Statutory Review Design Response

Morland Gardens, London Borough of Brent

Following the receipt of comments from GLA, TFL & Brent Highways on the submitted scheme for Morland Gardens, this document has been produced in order to respond to those comments and show how the scheme has been amended.

1.
Greater London Authority - GLA/5444/01 - 09.03.2020
(GLA Comments)
2.
Transport For London - BRNT/20/7 - 20.03.2020
(TFL Comments)
3.
LBB Highways - D91/1324EP/1 - 25.03.2020
(LBB Highways Comments)

Deliveries & Servicing From Morland Gardens

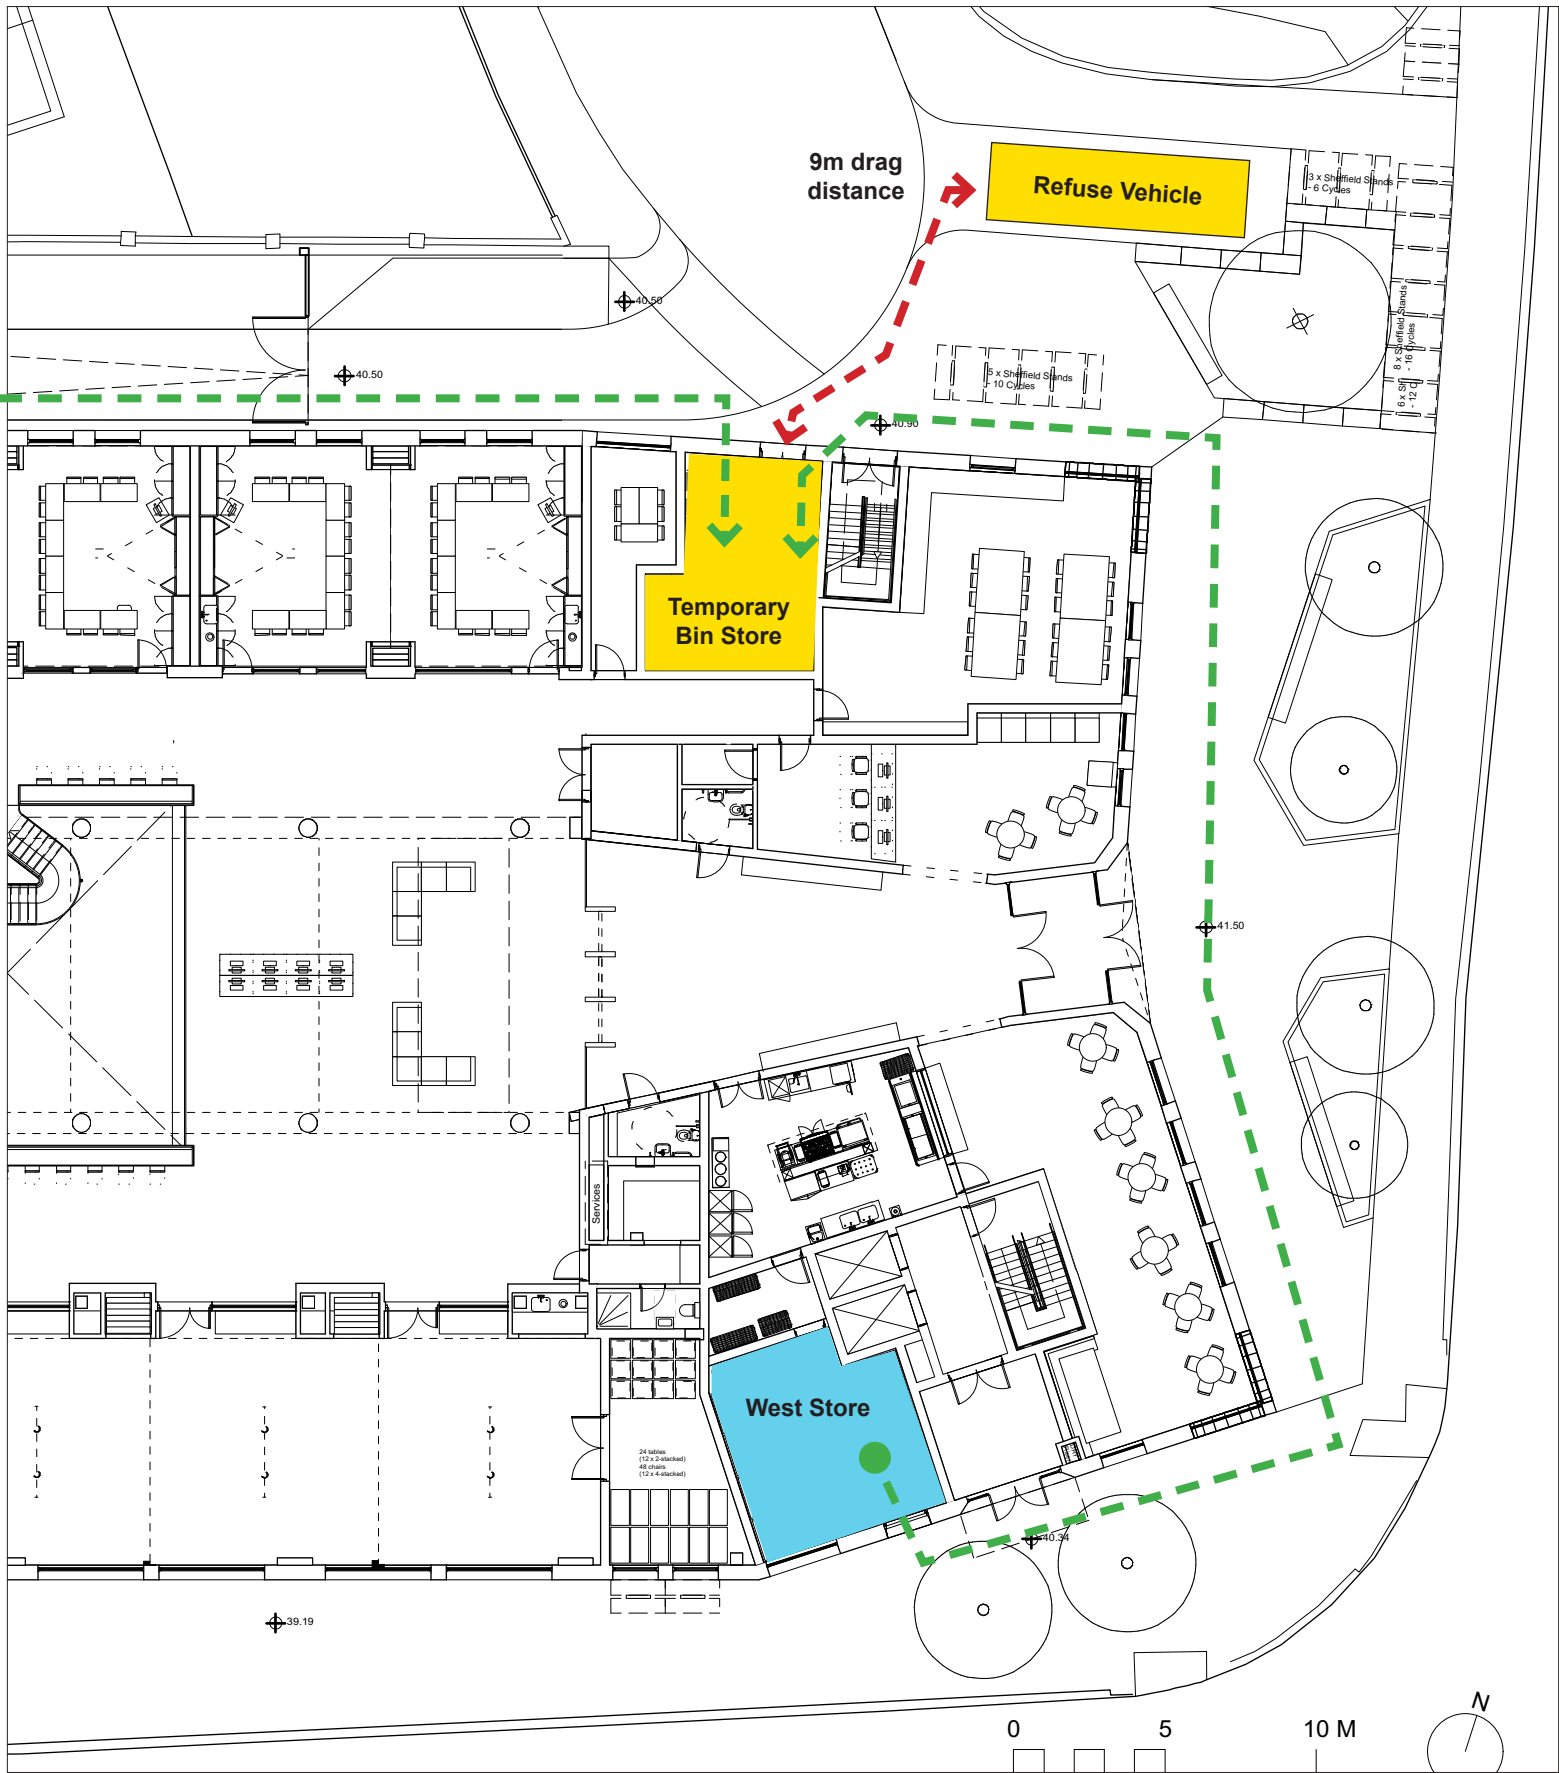
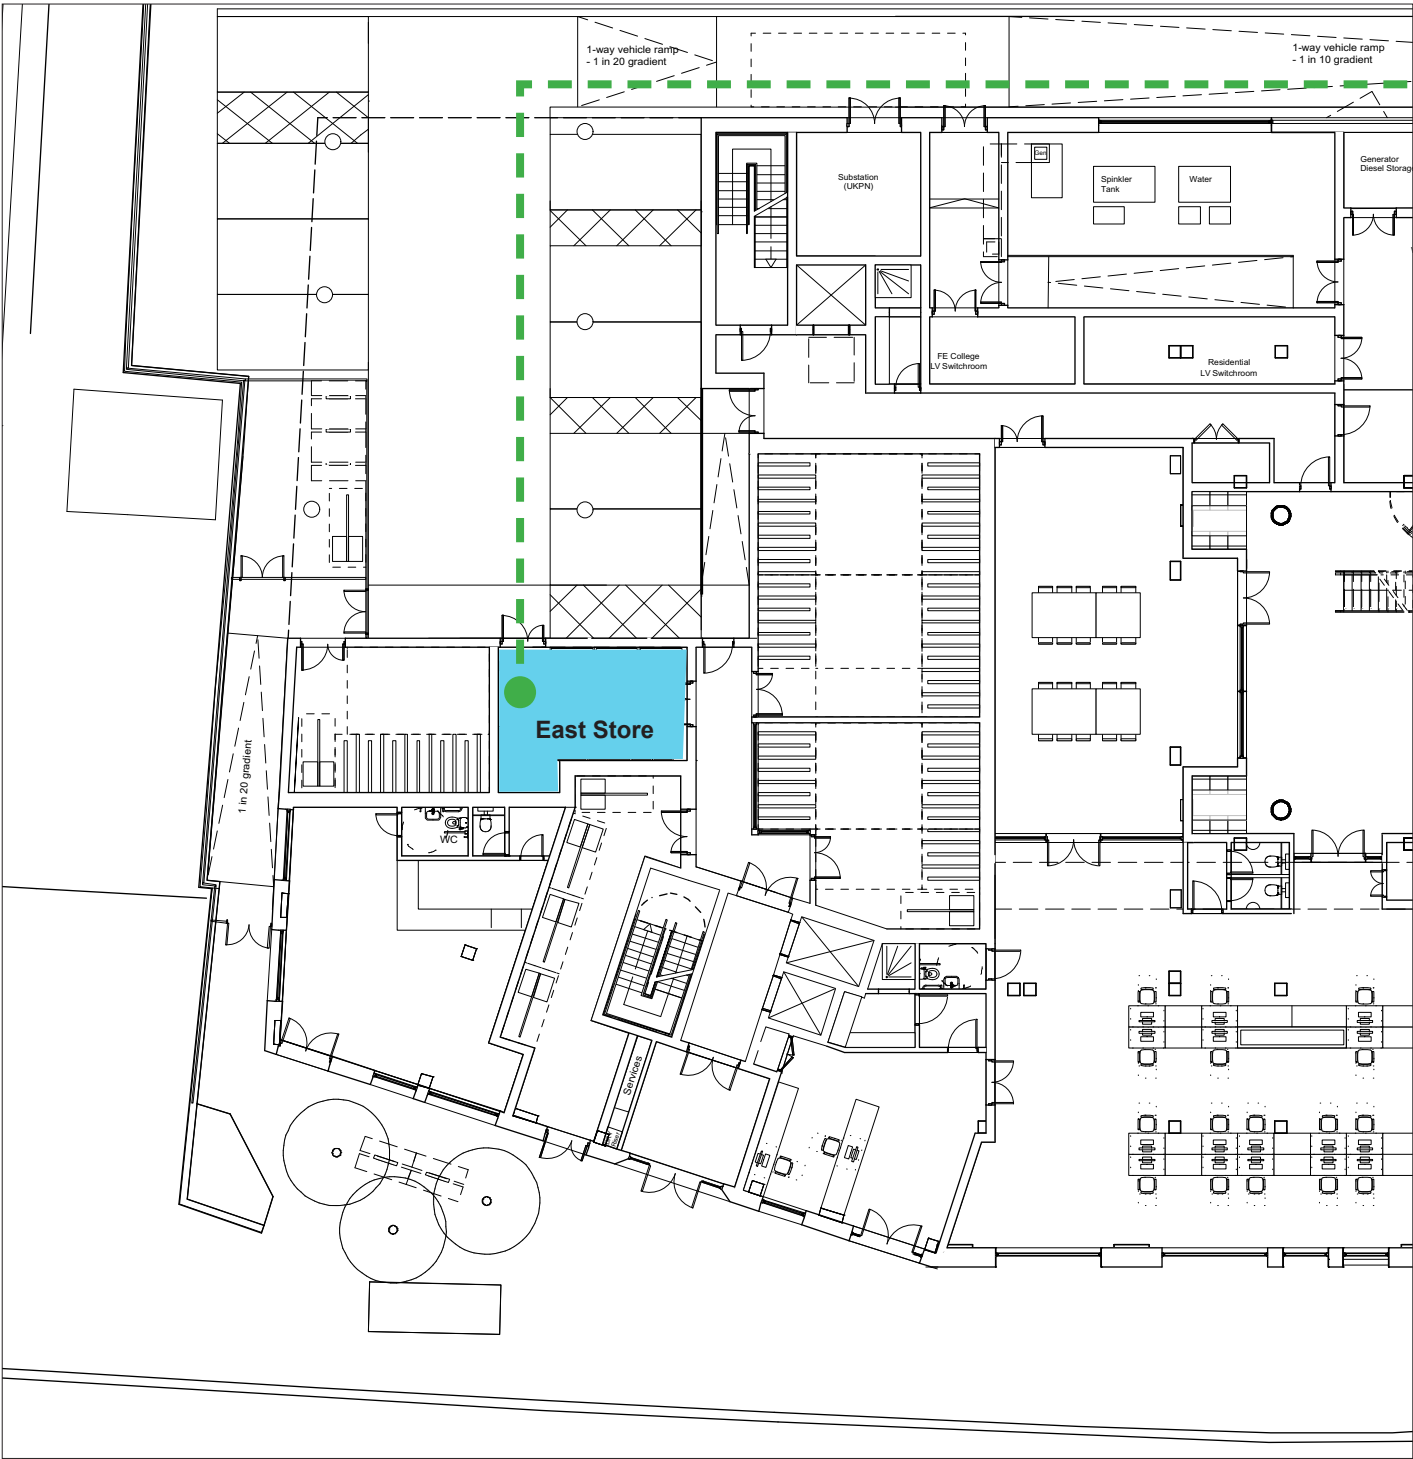
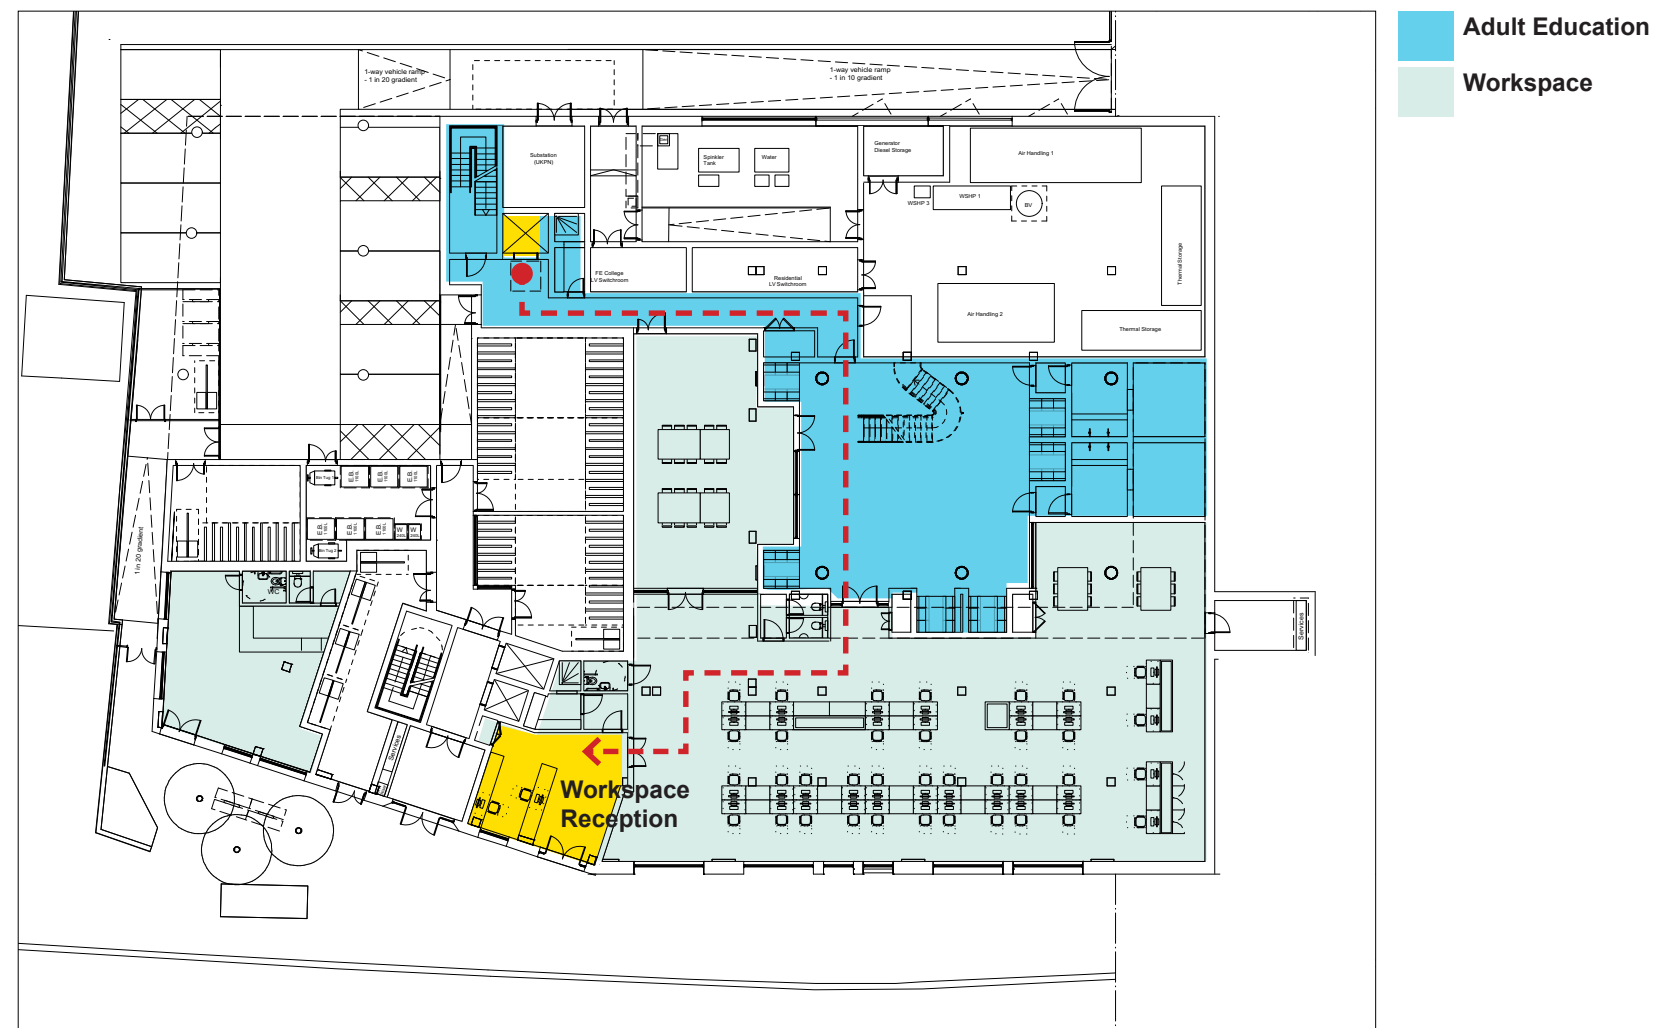
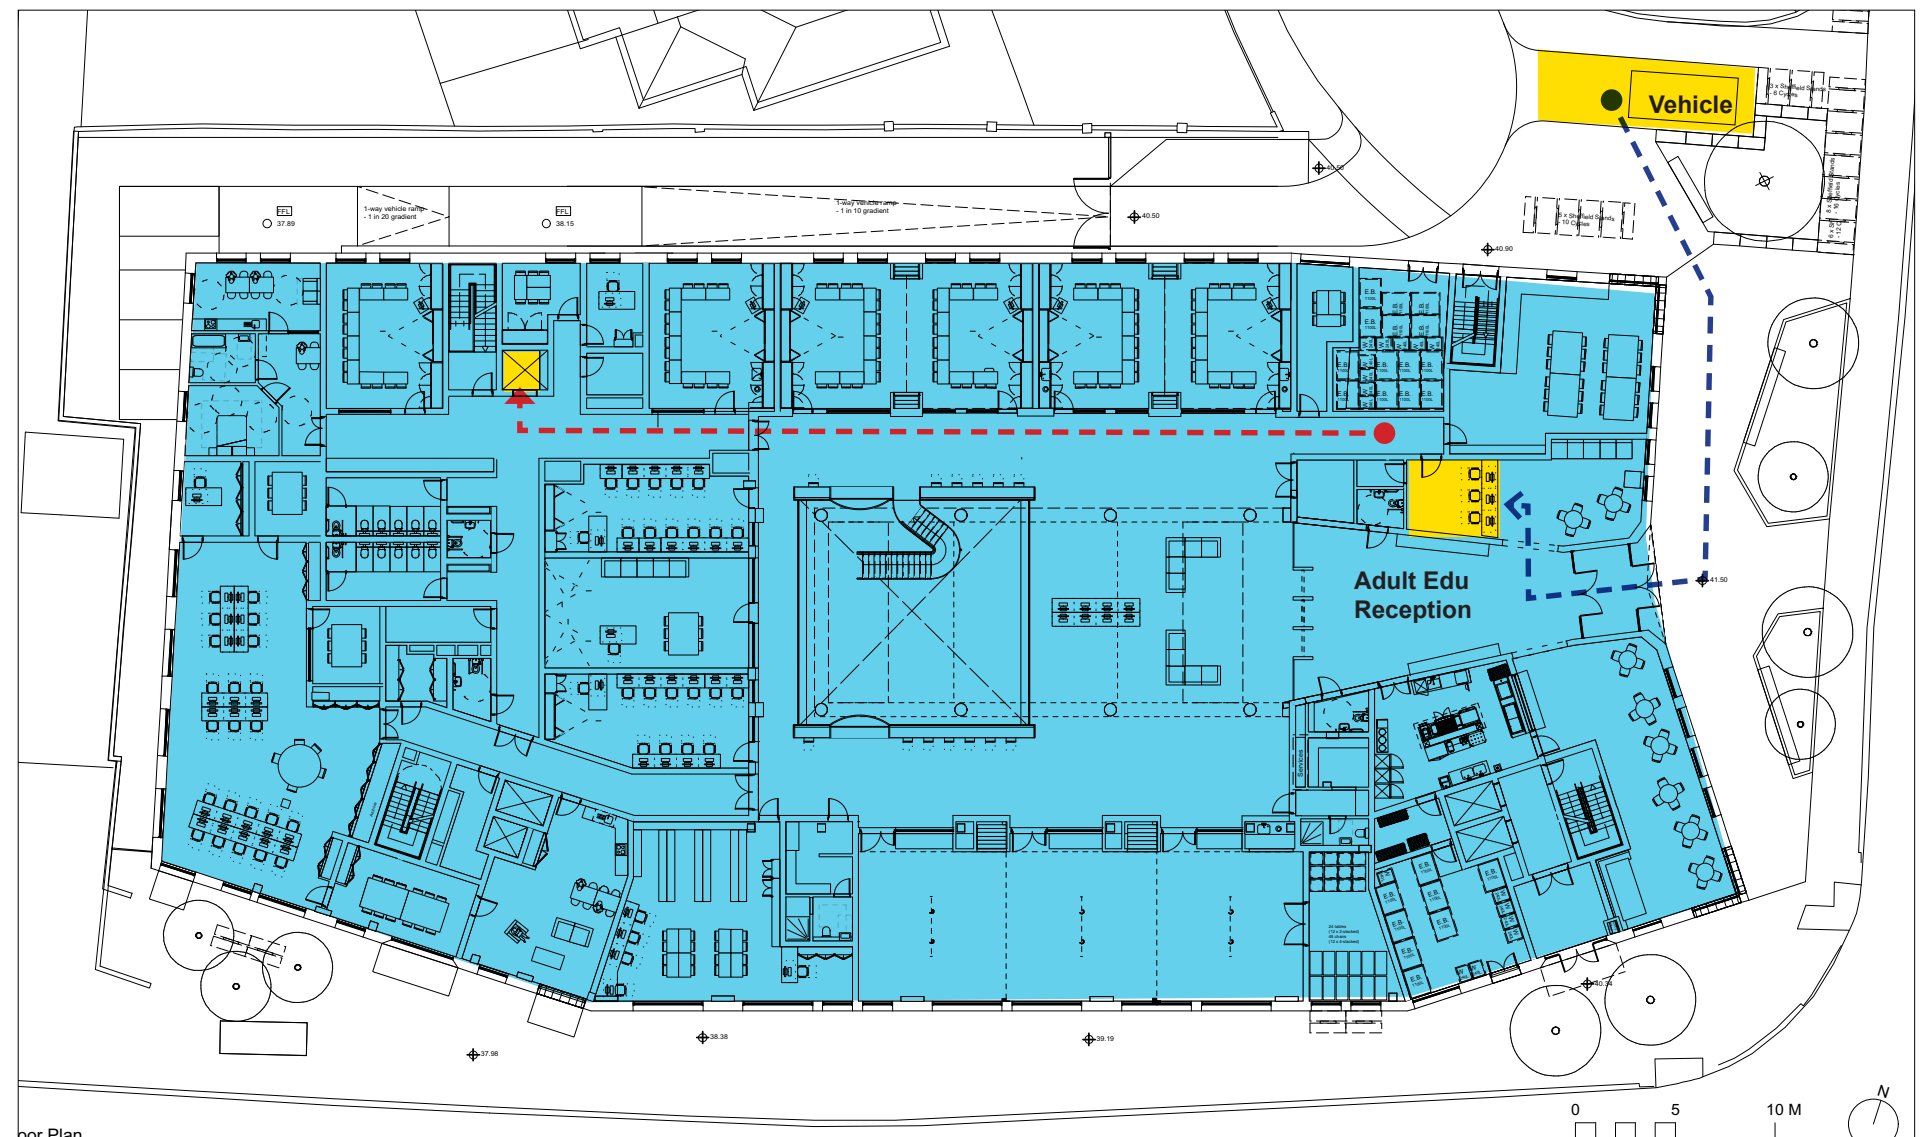
GLA Comments paragraph 54
‘the proposed servicing arrangements raise concerns in terms of compliance with the Mayor’s Intend to Publish London Plan Policies T2 and T7 and should be reconsidered.’

TFL Comments, page 3, Access
‘The proposed servicing arrangements are not acceptable in line with Intend to Publish London Plan Policies T2 and T7.’

A shared surface loading bay has been provided in the north east corner of the site at the termination of Morland Gardens. This should will also allow vehicles adequate space to turn around.

An additional temporary bin store is required within the building which will hold the refuse from all parts of the building to allow for appropriate drag distances from a refuse vehicle.

Deliveries for the workspace will be made via the reception area of the Adult Education Use.

The facilities manager of the Adult Education use will transport goods internally to the reception area of the workspace via a goods lift.
